JOB TITLE:
 Russell Hotel
 Russell Sq, London

DRAWING TITLE:
 Elevation of Entrance Doors

JOB TITLE:
 Russell Hotel
 Russell Square, London

Door & Frames
GD11.01 & DG23.02

Title: **THE RUSSELL HOTEL DG14.02**

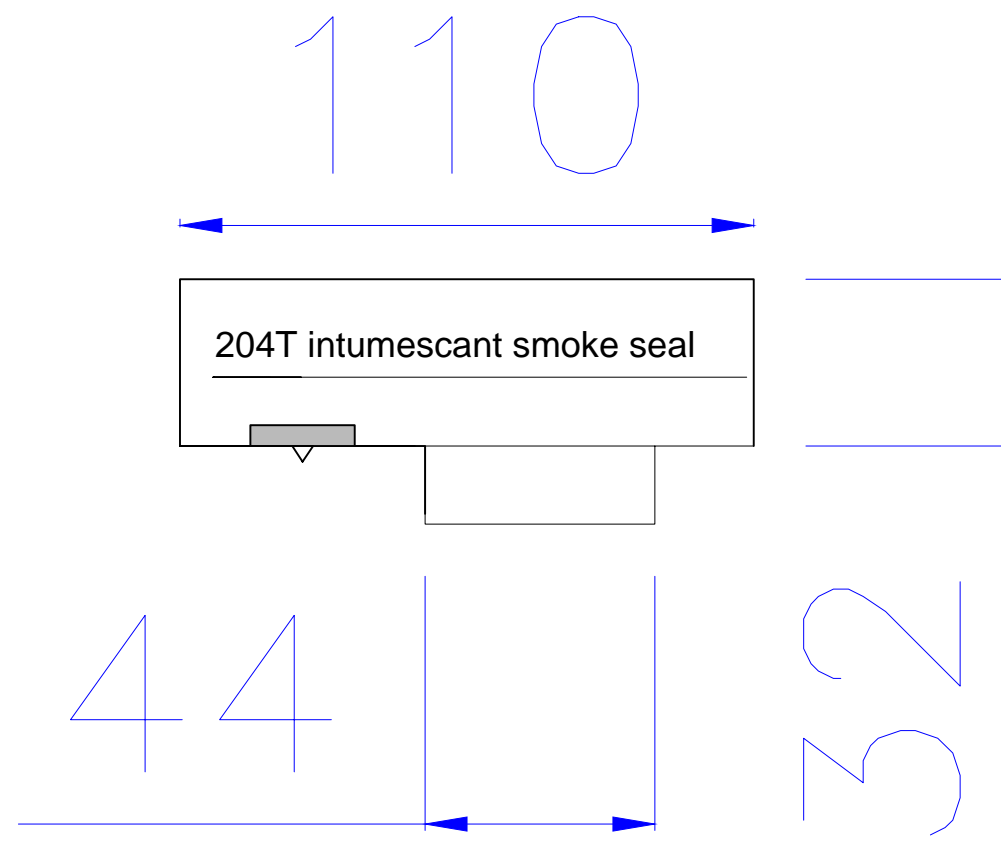
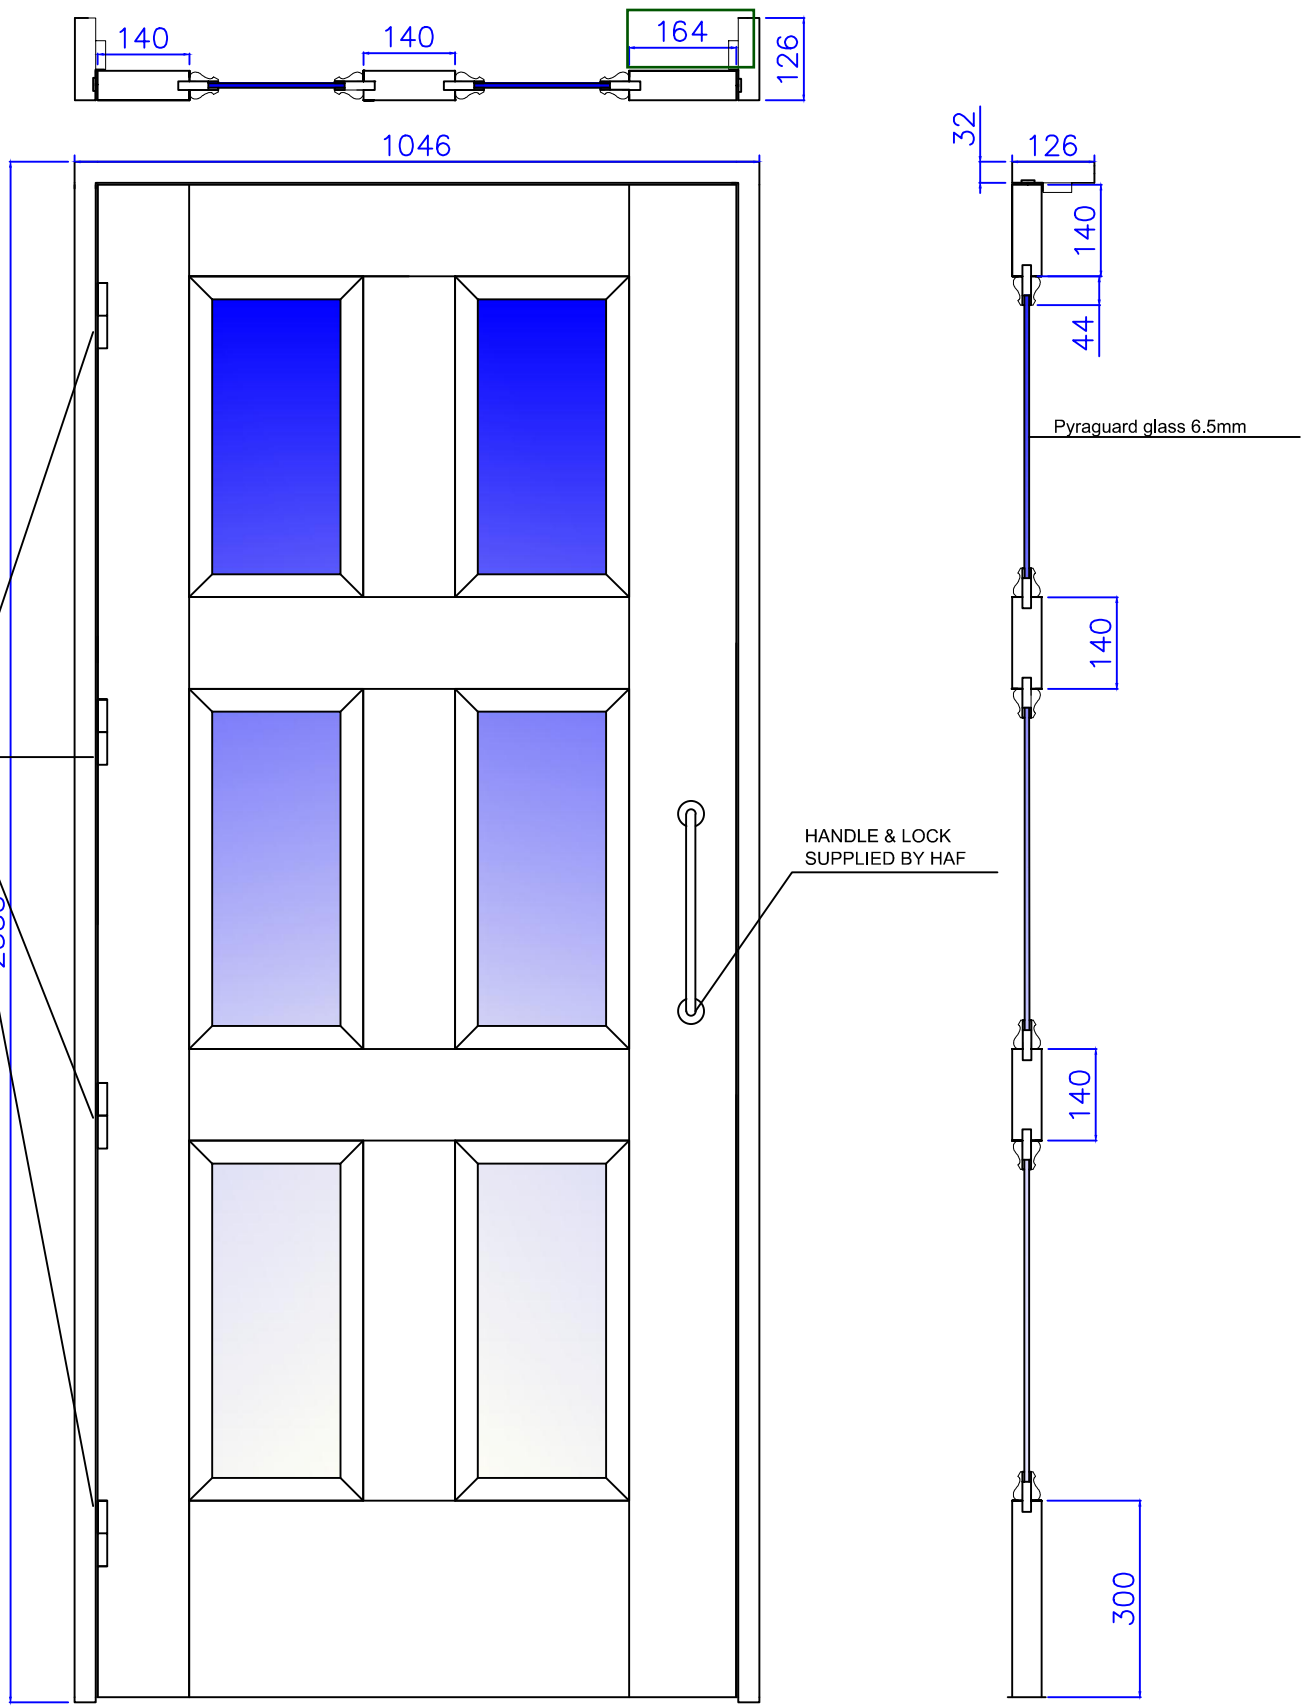
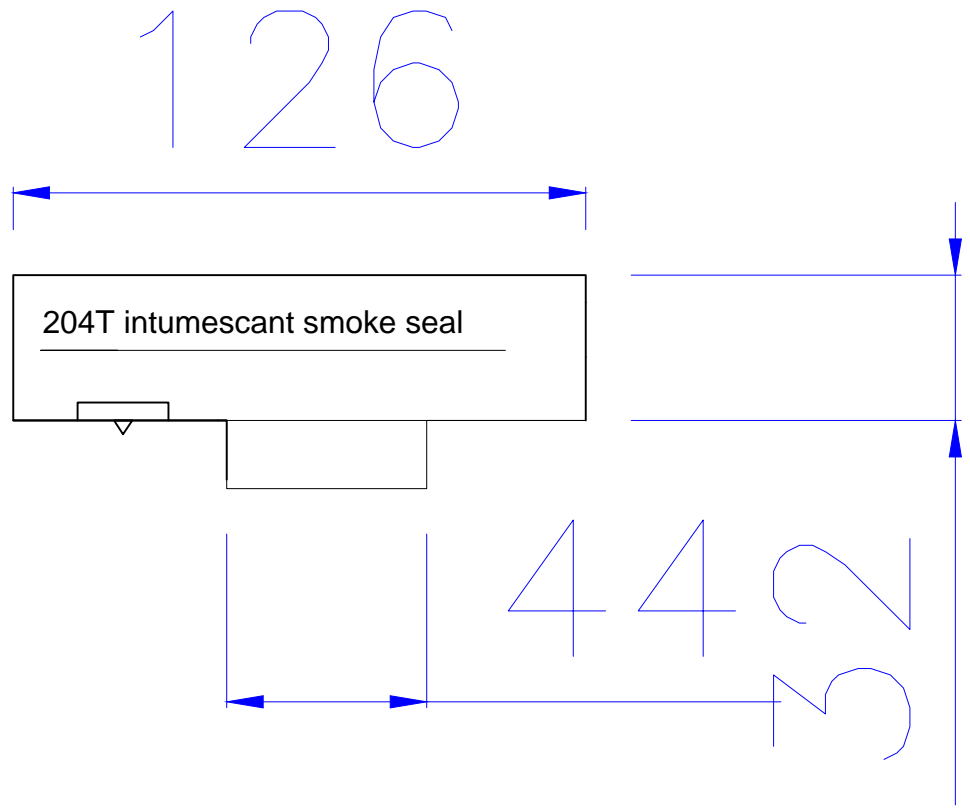
Epr comments:
 Mouldings and frame widths to match other GF doors - refer to Edmonds door drawings.
 Architraves by others - finish will need to match.
 Fire seals also required at base of door?
 Refer latest HAF schedule to ensure any recessed ironmongery is allowed for e.g. recessed door closers, lock barrels, electronic locking etc
 Doors within existing openings to be site measured.
 Test certificates required at completion for new fire door sets.
 Refer to previous finishes comments from RSS 31.03.17

140mm frame as other doors

G10 side to be finished to match other Edmonds doors

DG.15.01FD30 S

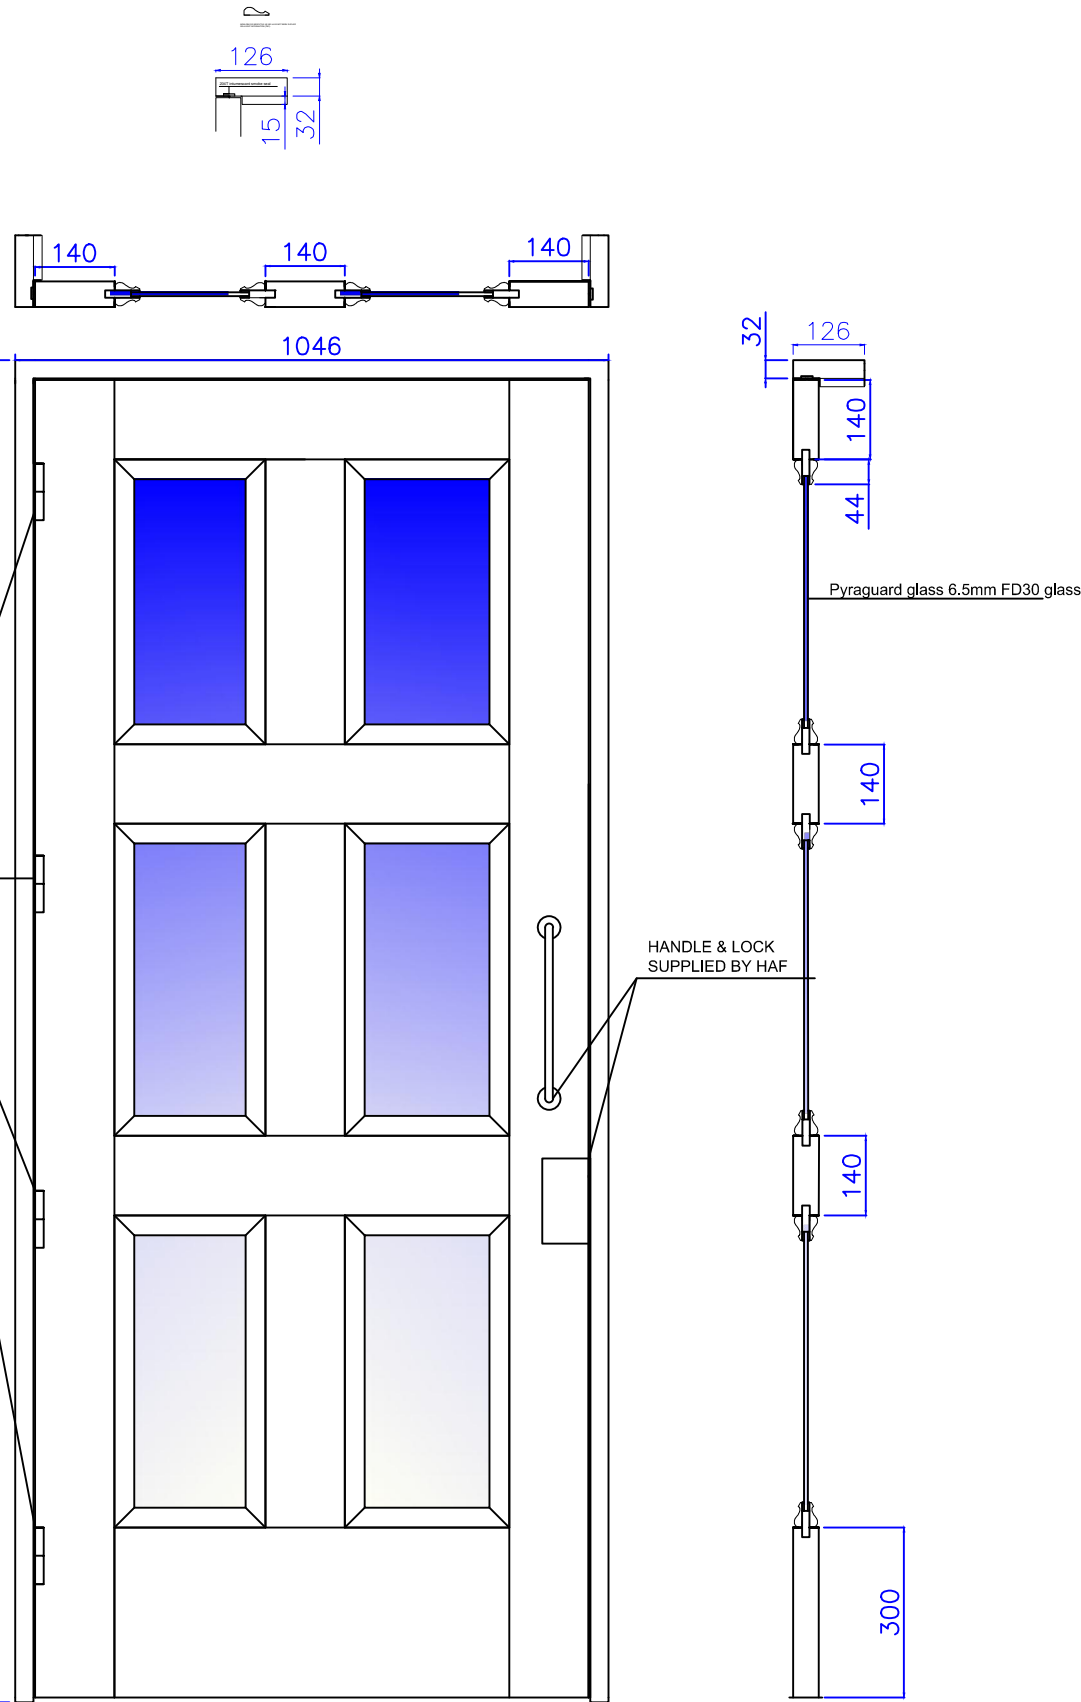
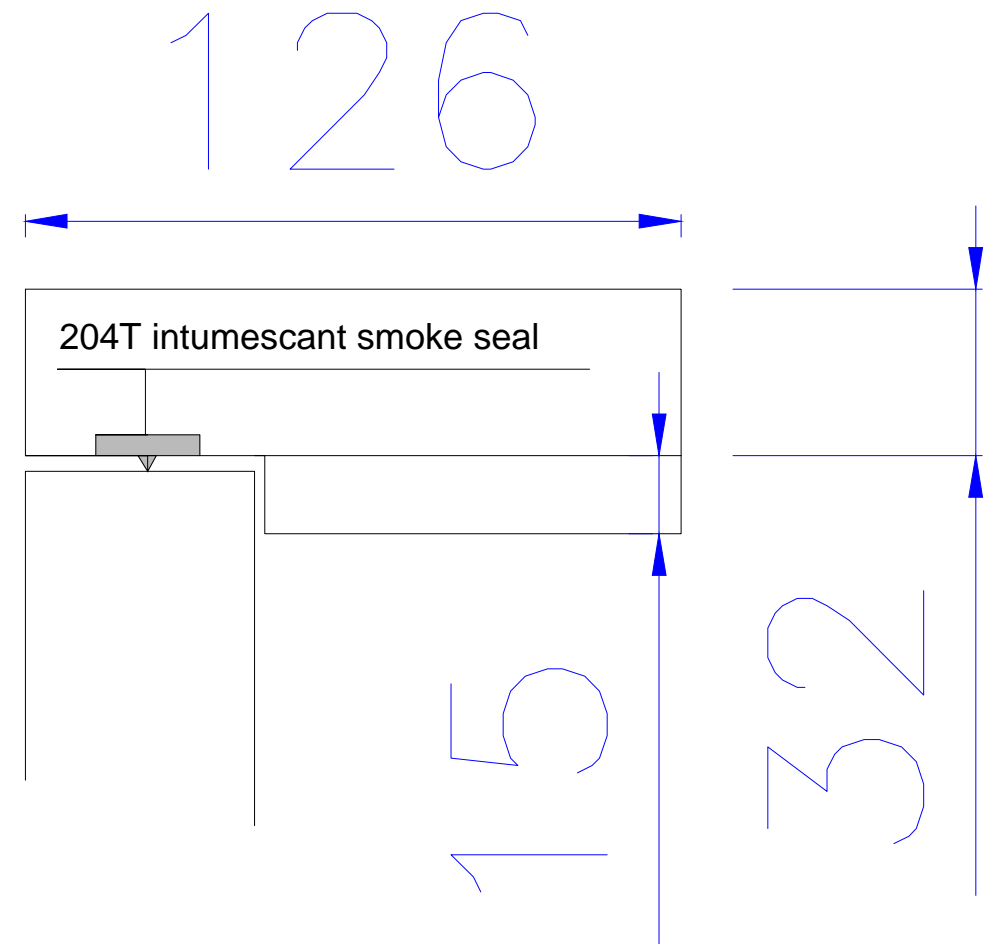
Epr comments:

Mouldings and frame widths to match other GF doors - refer to Edmonds door drawings.

Architraves by others - finish will need to match.

Fire seals also required at base of door?

Refer latest HAF schedule to ensure any recessed ironmongery is allowed for e.g. recessed door closers, lock barrels, electronic locking etc

Doors within existing openings to be site measured.

Test certificates required at completion for new fire door sets.

Refer to previous finishes comments from RSS 31.03.17

DG.16.01 FD30 S

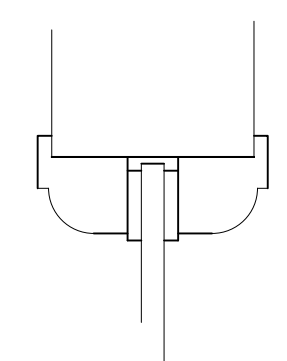
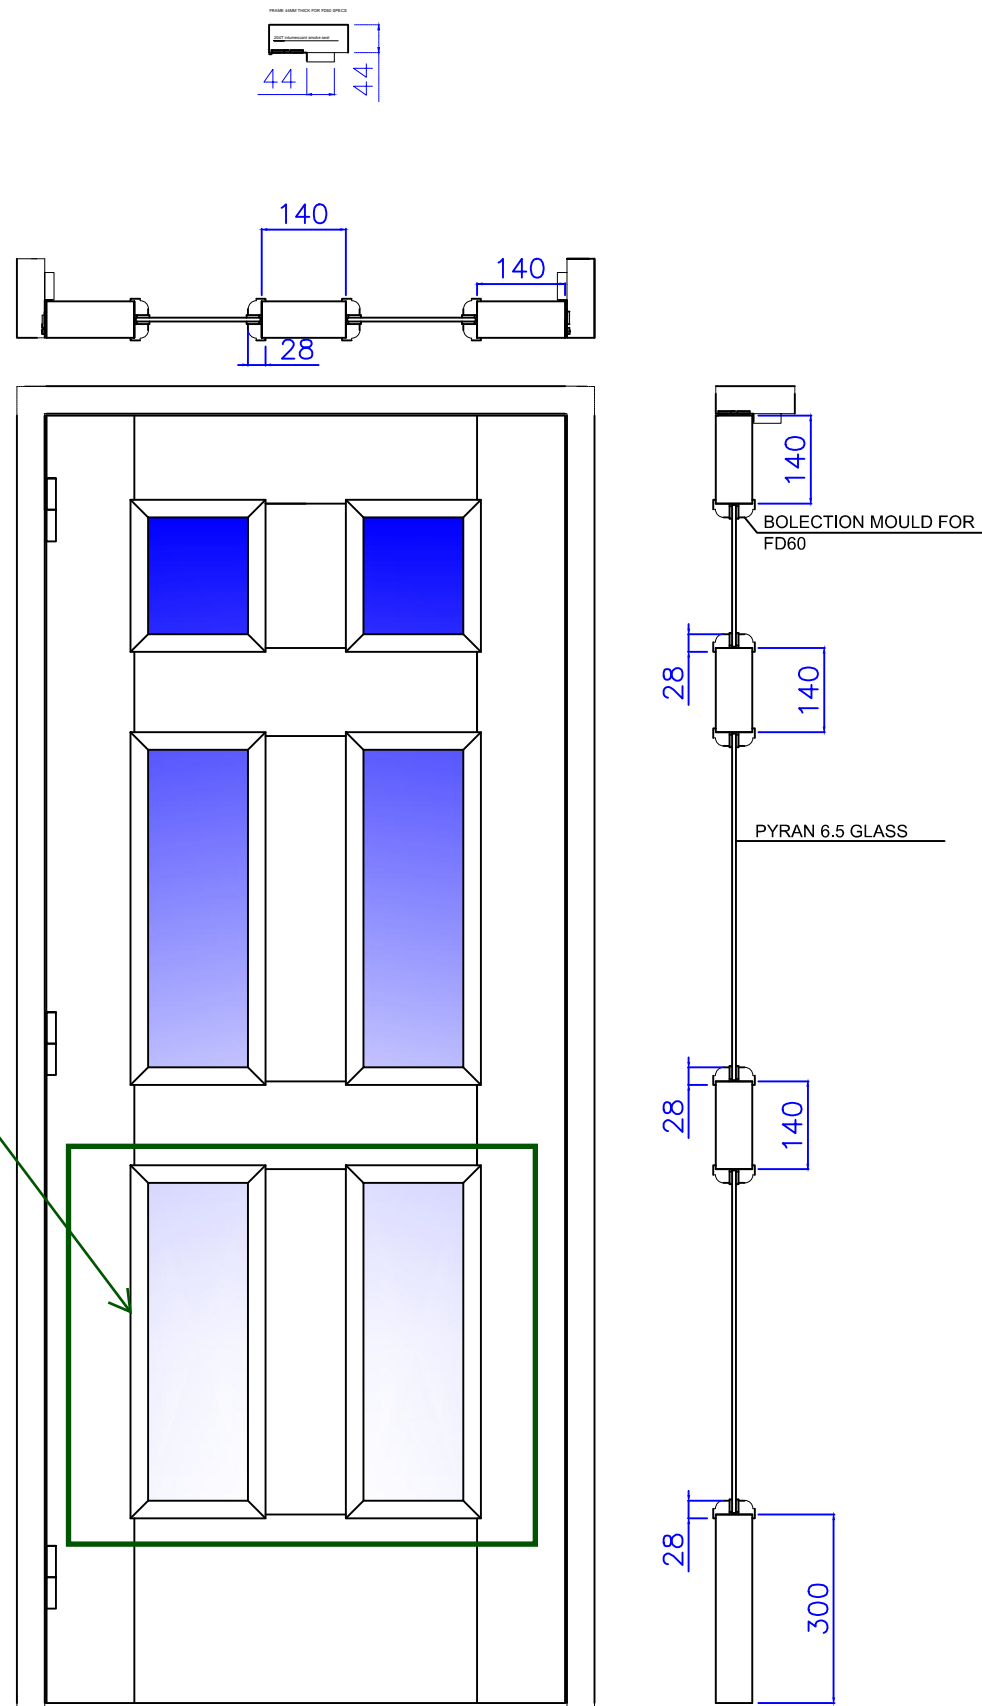
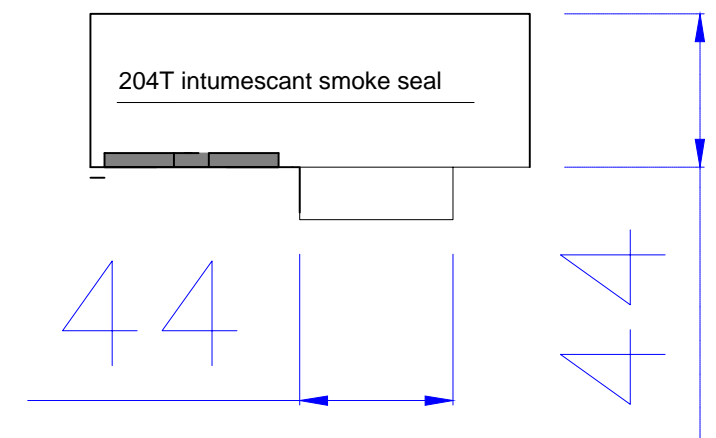
Epr comments:
 Mouldings and frame widths to match other GF doors - refer to Edmonds door drawings.
 Architraves by others - finish will need to match.
 Fire seals also required at base of door?
 Refer latest HAF schedule to ensure any recessed ironmongery is allowed for e.g. recessed door closers, lock barrels, electronic locking etc
 Doors within existing openings to be site measured.
 Test certificates required at completion for new fire door sets.
 Refer to previous finishes comments from RSS 31.03.17

bottom panels solid as RSS elevs

existing frame replaced? check on site
 FRAME 44MM THICK FOR FD60 SPECS

Title: THE RUSSELL HOTEL DG18.01

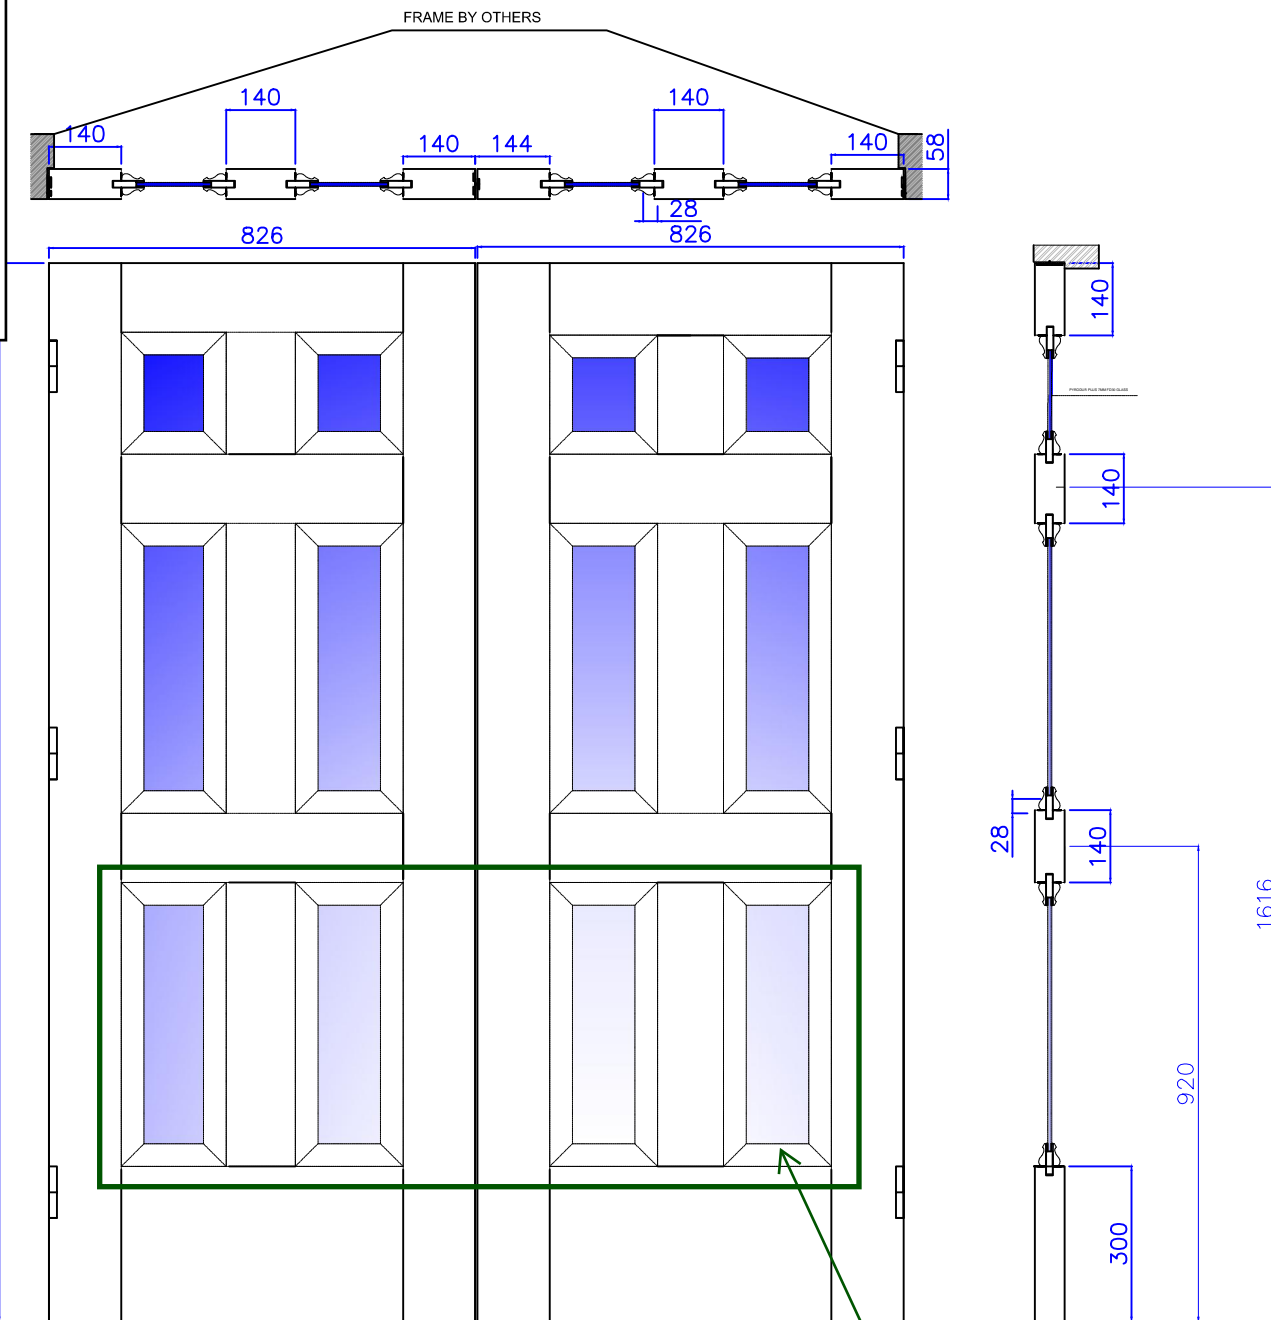
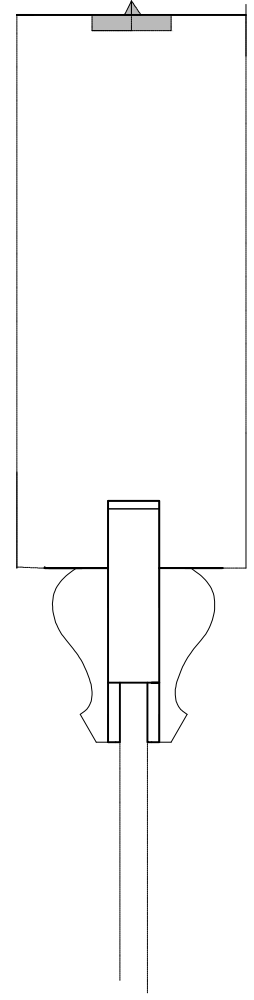
Epr comments:
 Mouldings and frame widths to match other GF doors - refer to Edmonds door drawings.
 Architraves by others - finish will need to match.
 Fire seals also required at base of door?
 Refer latest HAF schedule to ensure any recessed ironmongery is allowed for e.g. recessed door closers, lock barrels, electronic locking etc
 Doors within existing openings to be site measured.
 Test certificates required at completion for new fire door sets.
 Refer to previous finishes comments from RSS 31.03.17

bottom panels solid as RSS elevs
